Our ref: APP/HS2/18
Your ref: HS2/2021/0005

14 May 2024

**HIGH SPEED RAIL (LONDON TO WEST MIDLANDS) ACT 2017 – SCHEDULE 17
APPEAL MADE BY HIGH SPEED TWO LIMITED (HS2 LTD) AGAINST THE DECISION
OF NORTH WARWICKSHIRE BOROUGH COUNCIL TO DECLINE TO DETERMINE THE
REQUEST FOR THE APPROVAL OF PLANS AND SPECIFICATIONS MADE UNDER
SCHEDULE 17 COMPRISING THE WATER ORTON CUTTING INCLUDING THE
BROMFORD TUNNEL EAST PORTAL AND ATTLEBORO LANE OVERBRIDGE AND
ANCILLARY WORKS
APPLICATION REF: HS2/2021/0005**

Water Orton Cutting looking eastwards, west of the cutting's merging with the proposed relocated tunnel portal

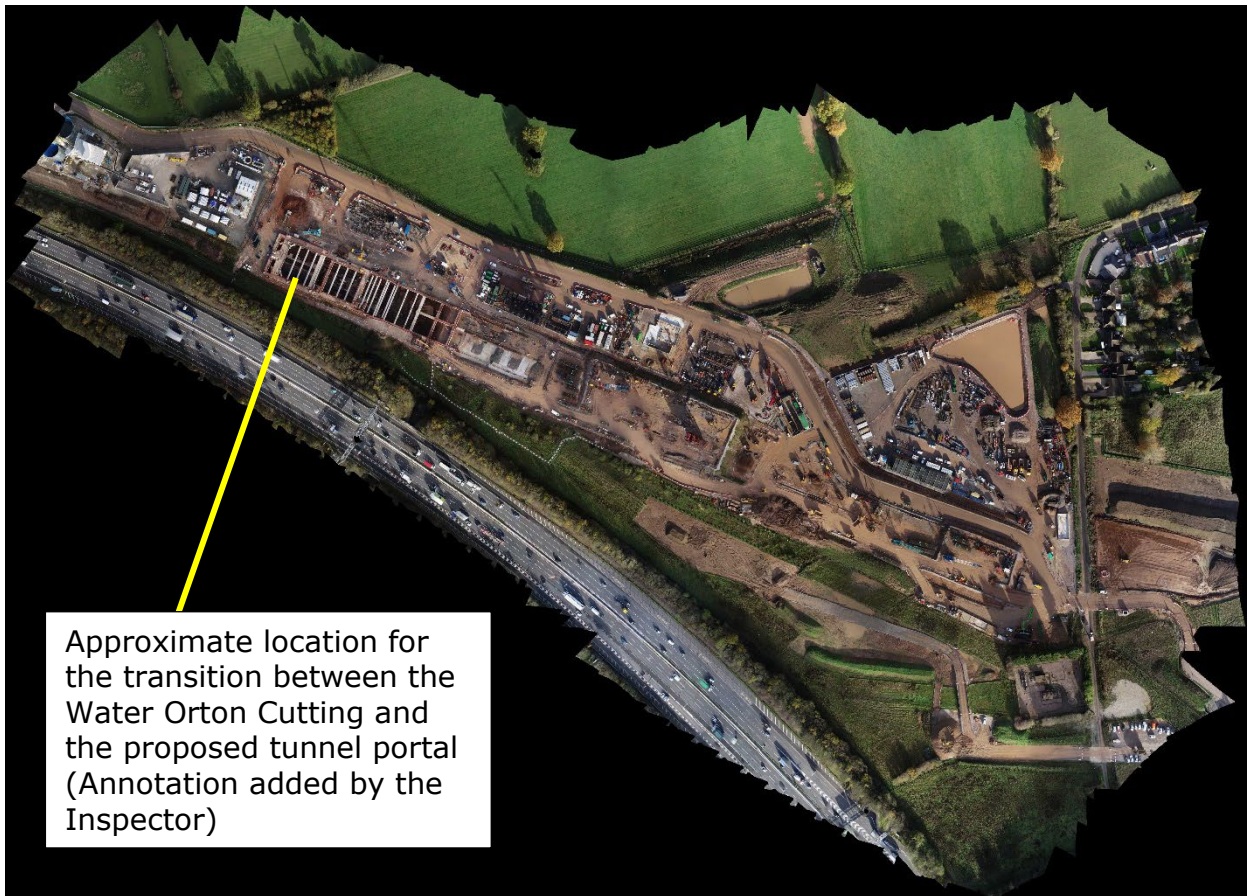
- because neither the ES nor scheduled WN3/157 specify what form the cutting should take.
59. A concrete lined cutting would have a very utilitarian appearance, which in part can be appreciated from the revised application drawings and my site visit photographs included in Appendix 2 to this report. However, the bulk of the cutting would not be readily visible because it would be 10 metres or more below ground level and/or would be screened from view by established vegetation to the south that adjoins the M6 and to the east by a combination of the formation of the embankments associated with the diversion of Attleboro Lane and the undertaking of soft landscaping. Some views down into the cutting would potentially be possible from the overbridge, although the presence of that bridge's parapets would be likely to significantly limit the views into the cutting. Taking those factors into account I consider the cutting when viewed from the east would not be unduly prominent or alien to its surroundings.

Figure 1 Cross section K

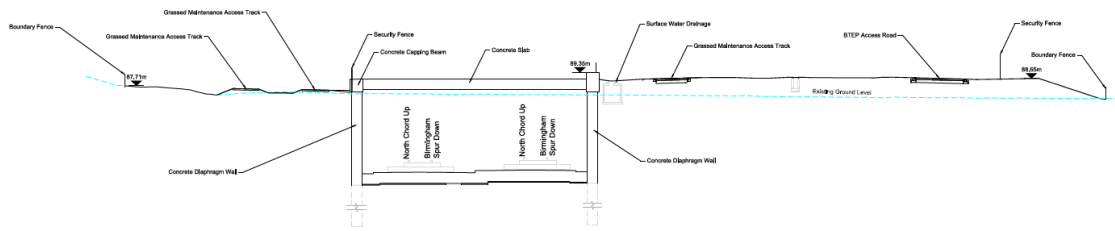
9. The portal would have a rectangular profile and it would terminate in the region of 50 metres to the north west at the proposed tunnel's eastern

10. The portal's concrete roof slab and capping beams would project around 1.0 metre above the proposed finished surrounding ground level and those above ground elements of the BTEP would be enclosed by 1.8 metre high security fencing. It is intended that some access tracks and parking would be provided on the portal's roof and would be needed for maintenance purposes.

11. The BTEP would largely be a subterranean structure. Consequently, I consider of the above ground elements of the BTEP, for which approval has been sought at this time, of themselves would not be unduly prominent and their appearance would be capable of being softened through the undertaking of soft landscaping. Landscaping does not form part of the works for which the appellant has sought approval under the appealed Sch17 application. Landscaping being a form of mitigation that can be considered in detail when bringing into use applications are submitted under paragraph 9 of Sch17.

Figure 2 Illustrative image of the tunnel portal and associated above ground structures

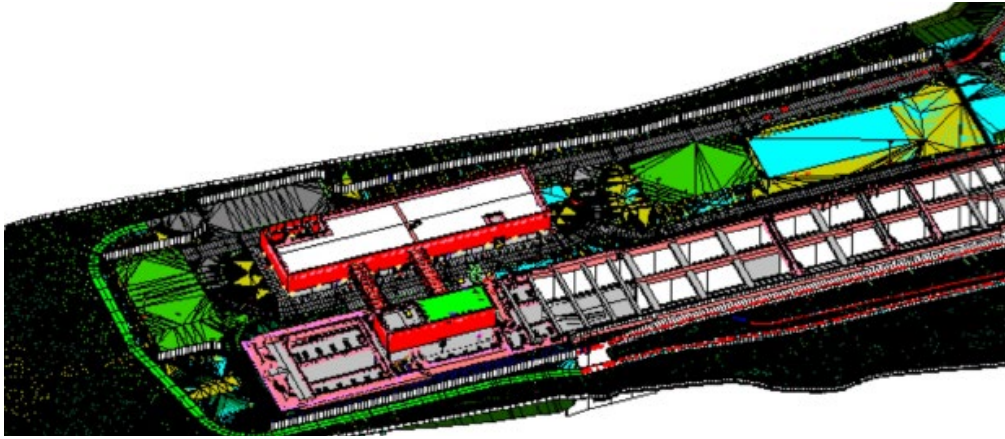
13. It is further intended that the proposed portal building would be linked via two gantries to a central portal shaft extending above the BTEP's roof. The appellant has also identified the need to locate an autotransformer within the vicinity of the BTEP and that would be located to the south east of the portal building. The extent of the land reserved for those above ground structures is shown on the submitted General Arrangements Plan (Appendix 1 to this report) and an illustrative image² for them can be seen in Figure 2.

14. A consequence of needing to provide a portal building and other above ground structures in the vicinity of the proposed BTEP would be the absence of much land, particularly to the north of the railway line, for the softening of the appearance of potentially unsightly functional structures. The relationship between the above ground structures, the proposed BTEP and land available to accommodate soft landscaping is shown in the illustrative landscaping and environmental master plan (LEMP) included in Appendix 2 to this report. The reference design assessed in the Environmental Statement (ES) for this stretch of HS2 was simply for a railway line in a cutting flanked by planting areas. A comparison between that reference design and what is now being proposed can be seen in Appendix 4 of my RR. The reference design included the undertaking of, amongst other things, a mixture of landscaped earthworks and landscape mitigation planting (scrub and woodland). By contrast the LEMP shows to the north of the BTEP generally low level planting (grassland and shrubs) and a narrow strip of what is described as "*high woodland edge*".

15. Full details of the above ground structures associated with the operation of the proposed BTEP have not been submitted by the appellant. Consequently, I consider such details could not reasonably be requested in connection with the determination of this appeal. That is because the appellant has expressly excluded a request for the approval of the plans and specifications for the above ground structures from the appealed Sch17 application. That led me in paragraphs 46 and 48 of my RR to express the view that the appellant's proposals were of a '*piecemeal*' nature because, in effect, a substantially different set of works are now being brought forward in '*... the absence of definitive details relating to the tunnel portal building, the autotransformer and any soft landscaping works*'.

Appendix 2 Indicative Landscaping and Environmental Master Plan

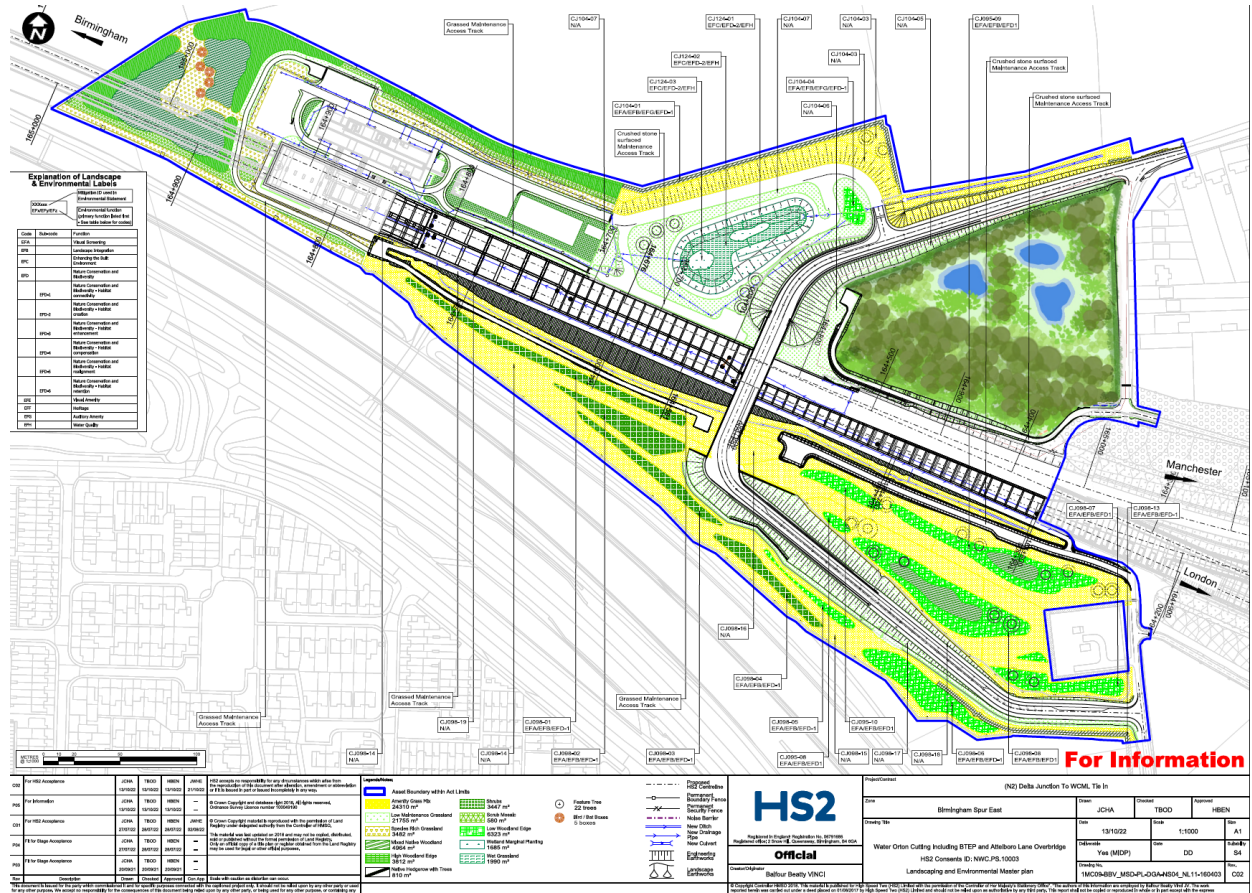
16. On the information available to me I have major reservations as to whether the soft landscaping works shown on the illustrative LEMP (Appendix 2 to this report) would provide effective mitigation for the above ground BTEP structures. Potentially the only way of addressing what might be the unsightly appearance of a standalone group of structures would be reliance a higher quality of design not usually reserved for this type of functional structure. However, that is not a matter that could reasonably be secured through the imposition of any conditions under paragraph 2 of Sch17 because the portal building and other above ground structures associated with the proposed BTEP are not within the appealed application's scope.
